B26.014 — CUYAMACA COLLEGE AUTO LIFTS REPLACEMENT

ADDENDUM NO. 2

Cuyamaca Community College Building K Auto Lifts Replacement Project

DSA #04-124611 FILE #37-C5 RCA Project No. 1-110-01

FLOOR PLAN NORTH - POWER & COMM.

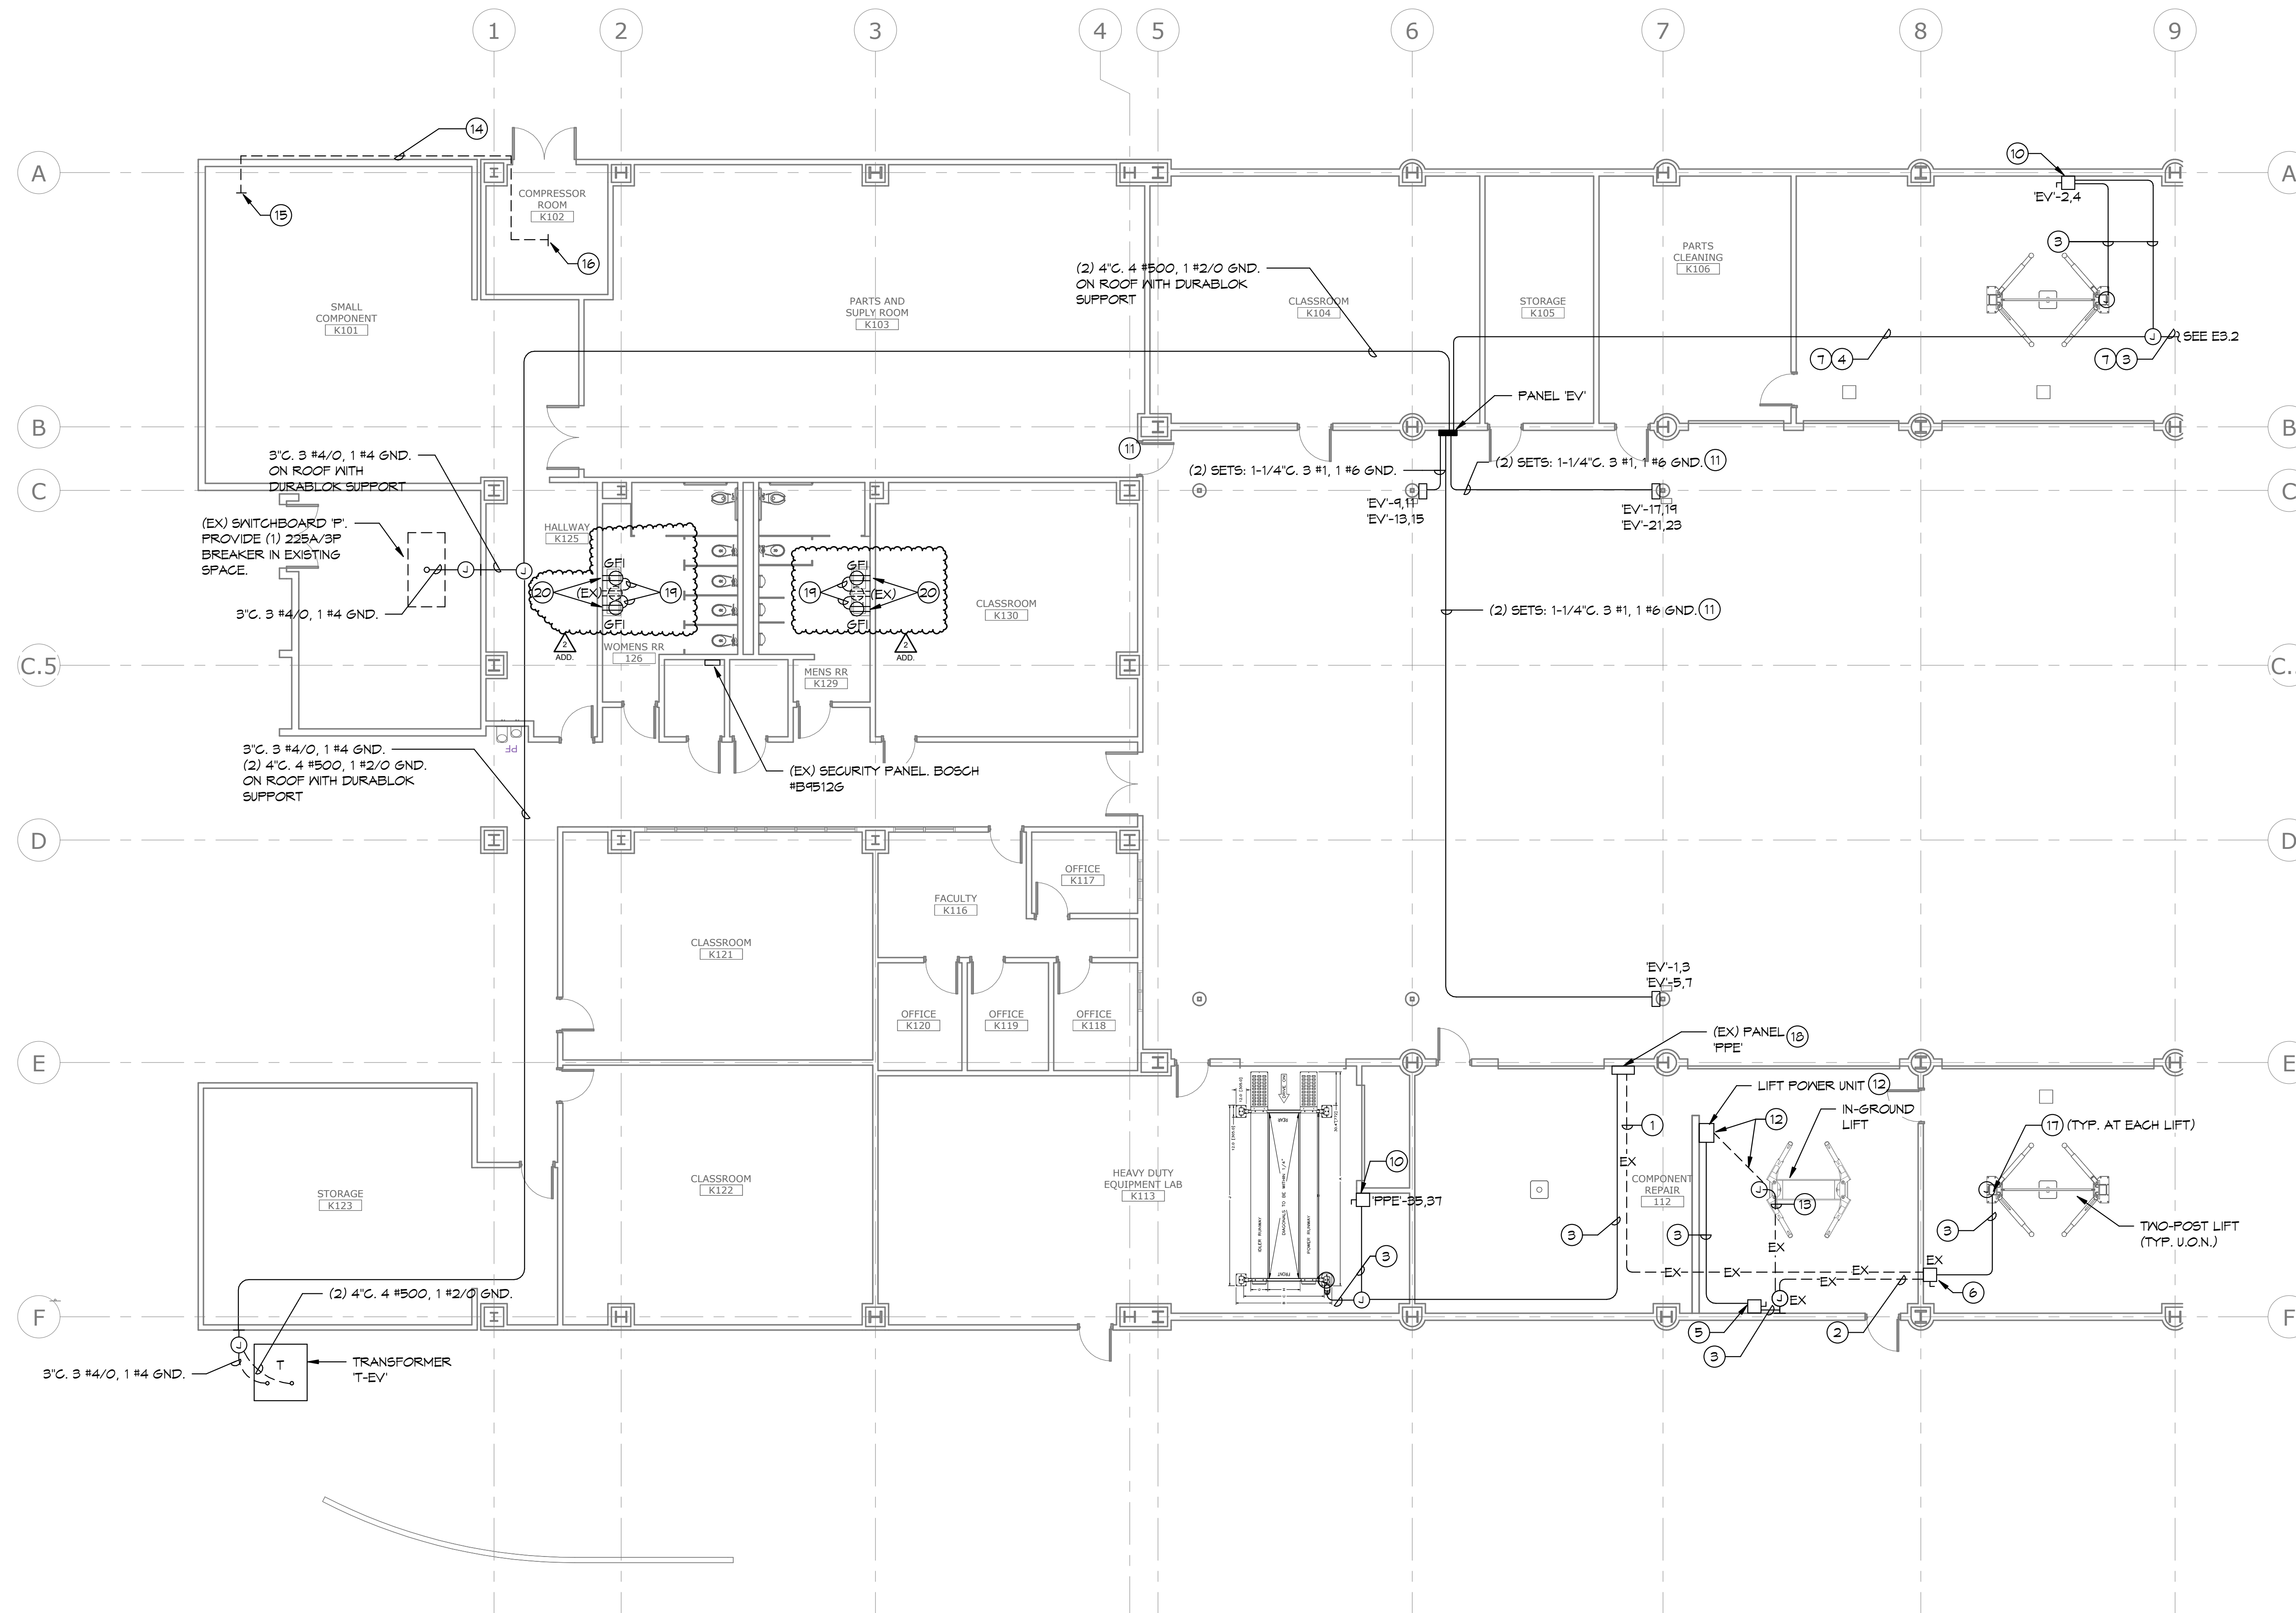
- Item No. 1.9 Reference Sheet E3.1 – FLOOR PLAN NORTH – POWER & COMM.
1.9.1 Revise Sheet per clouded areas below:
 (a) Added receptacles for lavatories.
- Item No. 1.10 Reference Sheet E3.3 – ONE LINE DIAGRAM & PANEL SCHEDULE
1.10.1 Revise Sheet per clouded areas below:
 (a) Revised one line diagram and panel schedule.

- RECEPTABLE FOR LAVATORY. FIELD VERIFY EXACT LOCATION PRIOR TO ROUGH IN.
